IREDELL COUNTY HEALTH DEPARTMENT

IMPROVEMENT PERMIT / CERTIFICATE OF COMPLETION / OPERATION PERMIT / EXISTING SYSTEM INSPECTION

OWNER OR CONTRACTOR Bobby Bearer PHONE: Business _____ Home 872-1045

☐ New System ☑ Repair System Type: I, II, III, IV, V, VI
System Description: Conventional, gravity fed
Repair System Description: _____
Maintenance Agreement Required: ☐ Yes ☐ No

INITIAL SITE SKETCH

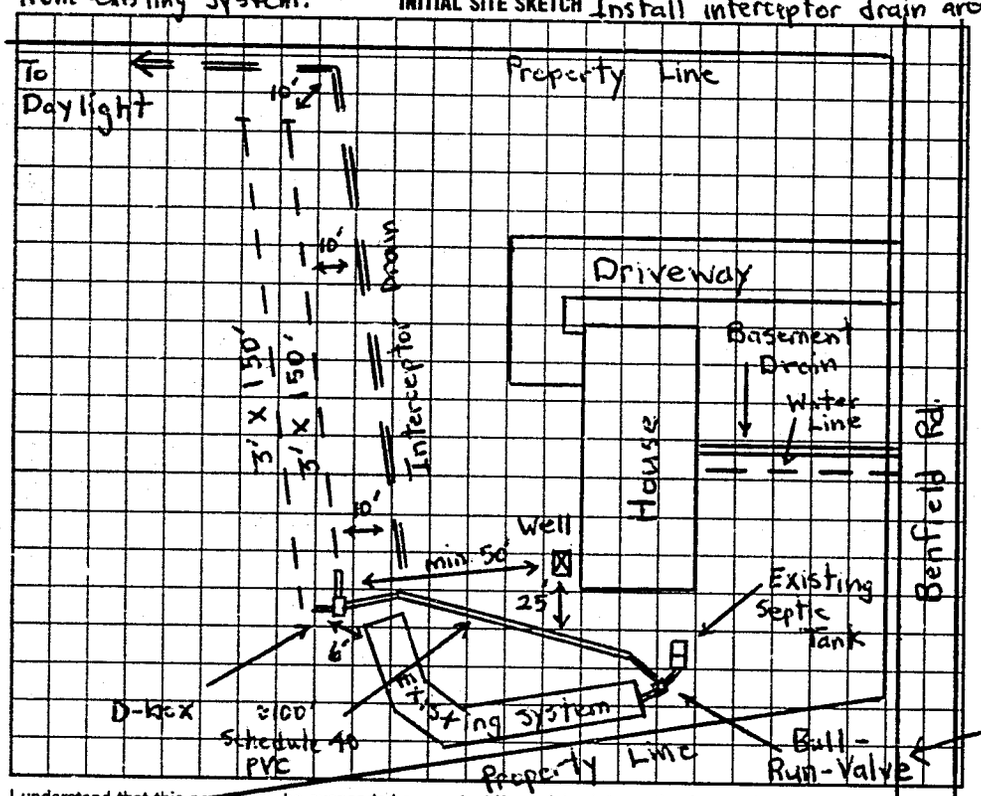
Comments: INSTALL SYSTEM SHALLOW (no deeper than 24" to trench bottom) Keep Nitrification Lines and Trenches on contour. Keep supply line min. 25' from well. Keep drain lines min. 50' from well. Keep system 10' from all property lines, 10' from Interceptor drain, and 6' from existing system.

Comments: Checked Lines 7-7-94. used tee instead of ball-run-valve due to old drain lines being clogged up. Interceptor drain checked 8-29-94. The first 30' did not have fall. If this caused problem, interceptor drain will have to be drained from both ends. This was O.K'ed by owner and contractor.

C.O.C not issued on 8-29-94 due to interceptor drain not running to day light. Checked it on 1-25-95

Install interceptor drain around septic system. Keep it min. 3' deep, 6" wide and fill with gravel up to 6" to surface. Run to daylight. From septic tank install Bull-Run-Valve between existing system and Repair. Call Health Dept. for inspection before adding gravel to interceptor drain. Install washing machine line into septic tank.

used tee instead of Bull-Run-valve.
